From: Nordine, John [nordine.john@epa.gov]
Sent: 4/1/2014 9:04:26 PM
To: Kristy Morrison [klmorrison@co.mchenry.il.us]
CC: Bob Kay [rtkay@usgs.gov]; Moore, Tammy [moore.tammy@epa.gov]; Peaceman, Karen [Peaceman.Karen@epa.gov]
Subject: RE: Tech Alloy Facility, Union

The Hydrological Assessment provided to the Department from Autumnwood ESH Consultants, LLC regarding the proposed high capacity well for the property denotes:

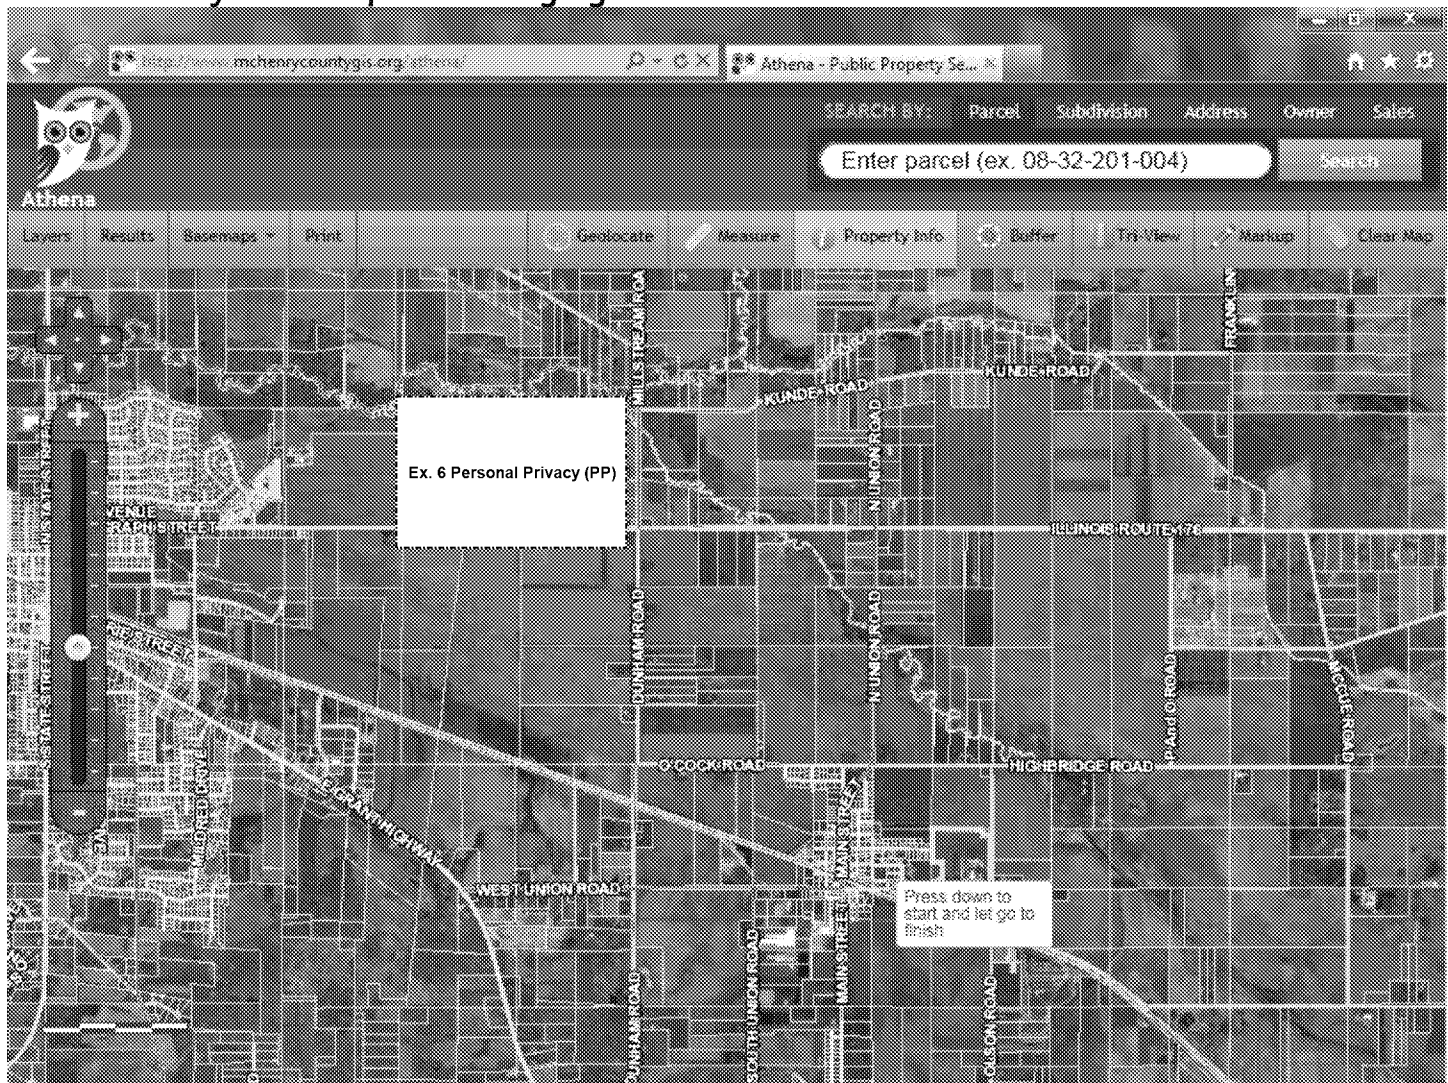
Could you please respond to the query from Kristy regarding the permit application for a proposed high capacity well?. If the contaminant plume originating from Techalloy is not stabilized and prone to expansion due to down gradient high capacity wells within the contaminated aquifer, it is worth looking into requesting the city to implement a groundwater ordinance for new well installation. Thanks.

We spoke last year regarding the Tech Alloy facility located in Union. I would like to confer with you regarding a permit application for a proposed high capacity water well located at Ex. 6 Personal Privacy (PP). I believe in our previous conversation you mentioned that the installation of the high capacity water well located at Ex. 6 Personal Privacy (PP) [which is the parcel east of this proposed permit application] changed the contamination plume direction from the Tech Alloy site and interfered with remediation efforts. If this is the case, could you please respond at your convenience if the proposed irrigation well will possibly interfere with the remediation efforts ongoing for the Tech Alloy site? I have enclosed an aerial view of the proposed well site in relationship to the Tech Alloy site. Both parcels are highlighted in blue.
